Flight Procedure Tracking Form		Action: FLIGHT CHECK	Task Type: TEXTUAL DP	Date Open: 02/03/2017	Task #: 2017011911260101001	Request #: 20170119112601
Procedure: CLEVELAND OH BKL AMDT 6			Airport ID: KBKL	Airport: BURKE LAKEFRONT		Reimbursable #: NO
City: CLEVELAND	ST: OH	GPS #:	Estimated Chart Date: 10/12/2017		FICO #:	
Fac ID: N/A		Fac. Type:		Specialist: JOHN THORNTON		
Procedure Review						
	Rec'd	Rel'd	Full Name	Comments		
Lead:	02/03/2017					
QA:						
Liaison:						
Procedure Comments:			Remark Type: INFORMATION			
APPROVAL LETTER: RWY 27L CLIMB GRADIENT EXCEEDS 500 FT PER NM. CONTACT ROBERT HAMILTON, AJV-542 MANAGER, 405.954.4608

Subject: **ACTION:** Approval Request

Takeoff Minimums and Obstacle Departure Procedure (ODP)
Takeoff Rwy 24L, Burke Lakefront, Cleveland, OH (KBKL).

BURKE LAKEFRONT (KBKL)
CLEVELAND, OH
DP RWY 24L, AMDT 6
- 757 FT PER NM TO 1000
SCALE: 1:100,000
3. OBS MANDATING ODP ROUTE DEVELOPMENT
5. VISIBILITY
6. CEILING/CLIMB-TO ALTITUDE
7. CLIMB GRADIENT

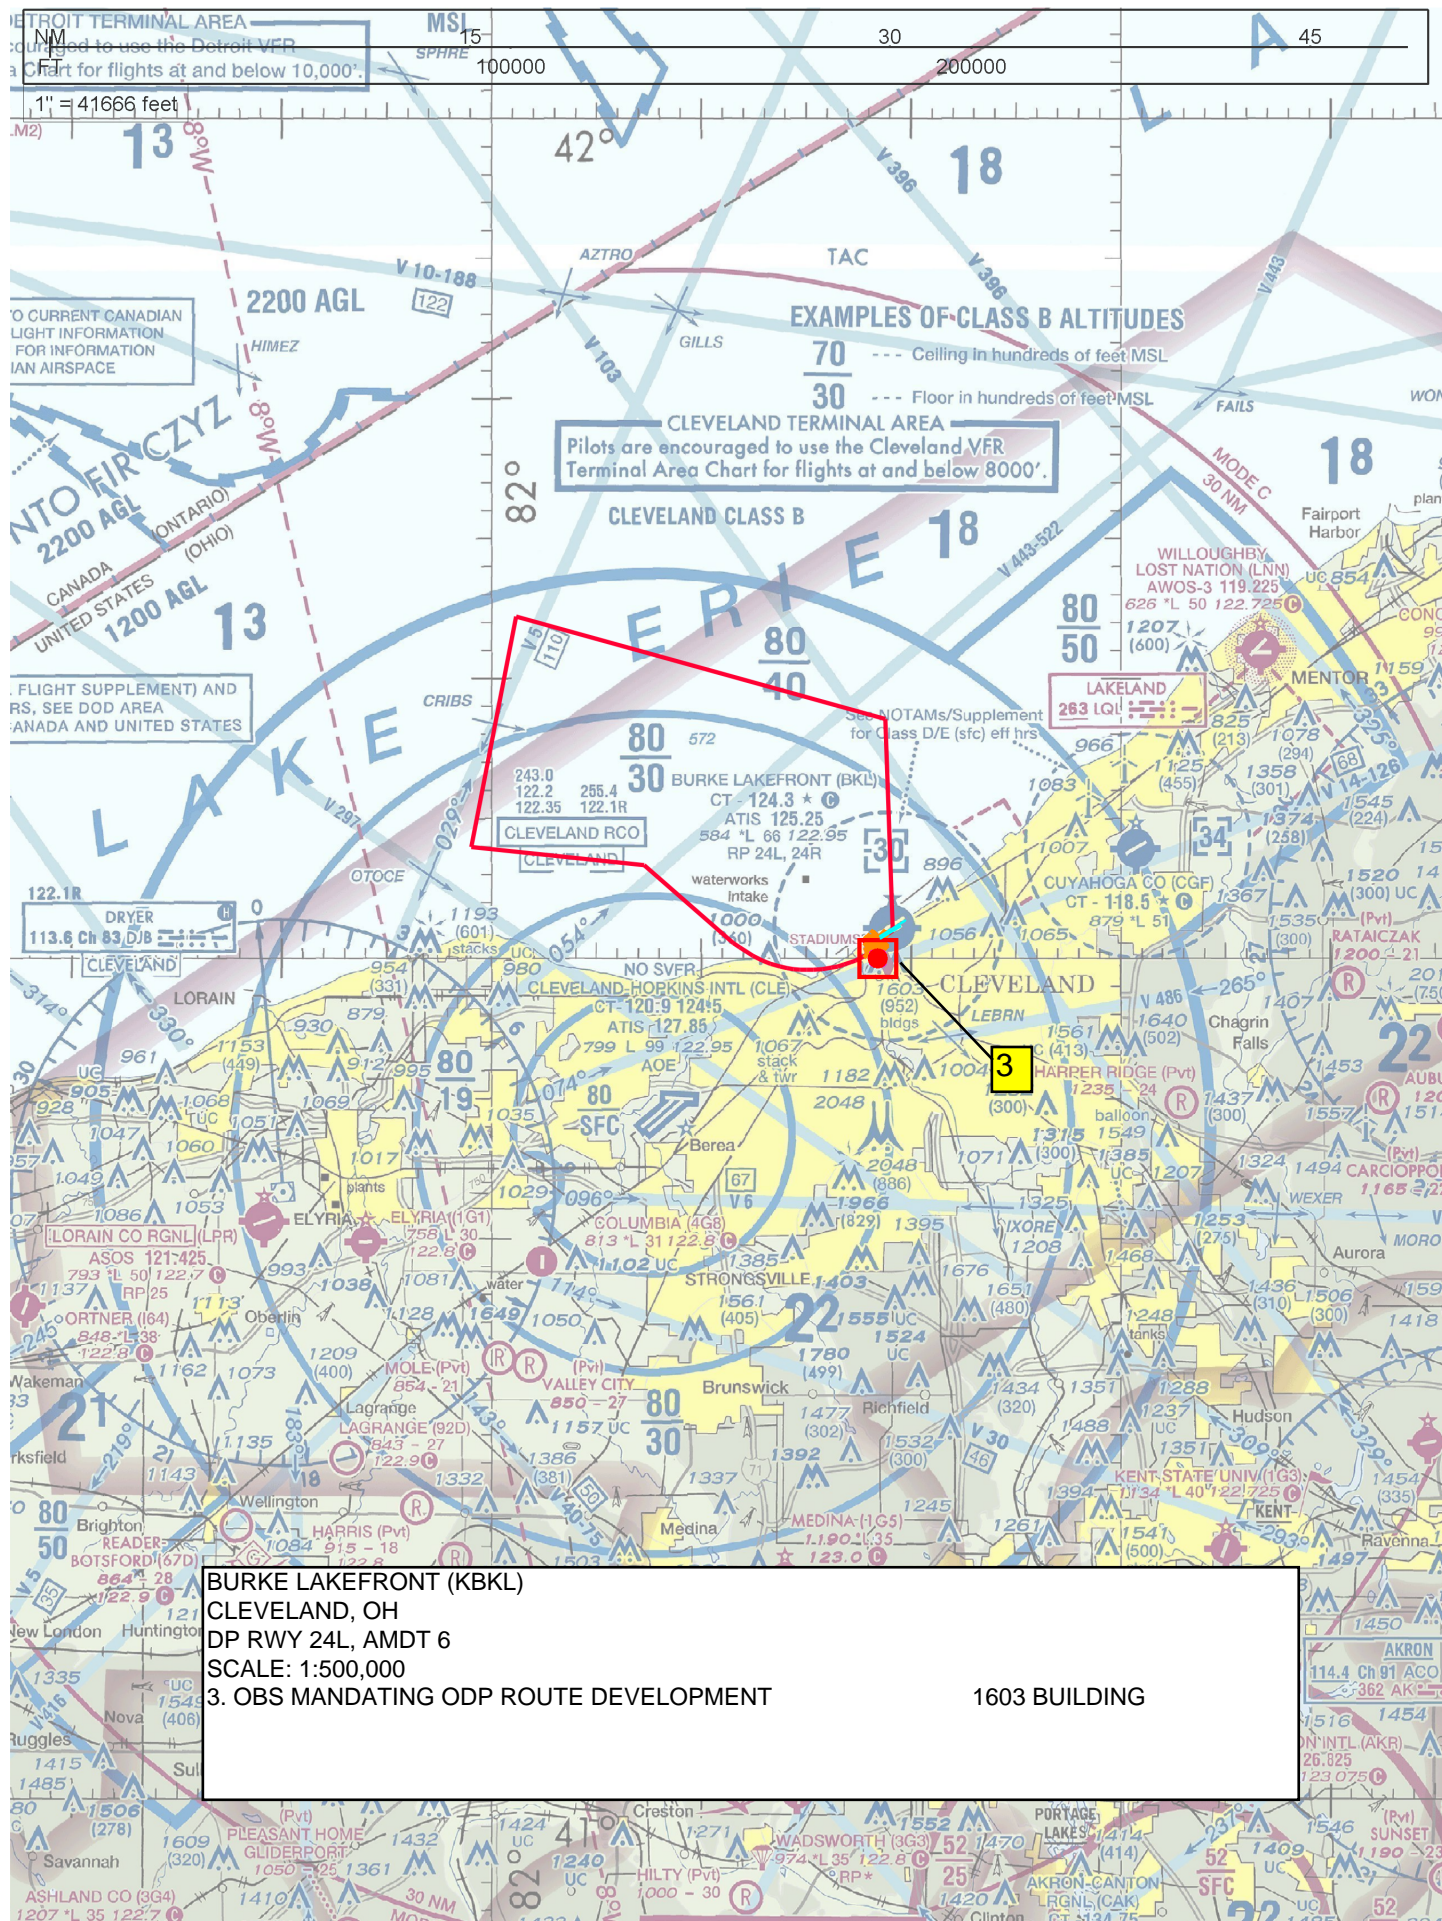
Climb gradient exceeds 500 feet per NM, 8260.46F, para 2-1-1d(2).

A 740 MSL building (39-022691) AC 1A 413031.10N/0814144.07W located 0.34 SM from the Rwy 24L departure end of runway in the ICA and it requires a climb of 757 FT per NM to 800. Additionally, an 896 MSL building (KBKLT000270) AC 1A 413004.41N/0814214.10W located 1.01 SM from Rwy 24L departure end of runway in the ICA requires a climb-to altitude of 1000. There are numerous other obstacles which also cause require climb gradients/climb-to altitudes and because of the location of these obstacles, a departure route to avoid them can't be constructed.

Rwy 24L ODP is currently published with a 761 FT per NM climb gradient and 900 MSL climb-to altitude. The climb gradient and climb-to altitude changes of 761 FT per NM to 757 FT per NM and 900 MSL to 1000 MSL are due to application of current criteria and new controlling obstacles.

Request to publish the following minimums: 400-1 3/8 or standard with minimum climb of 757 FT per NM to 1000.

If disapproved, we will annotate Rwy 24L takeoff minimums as NA-obstacles.
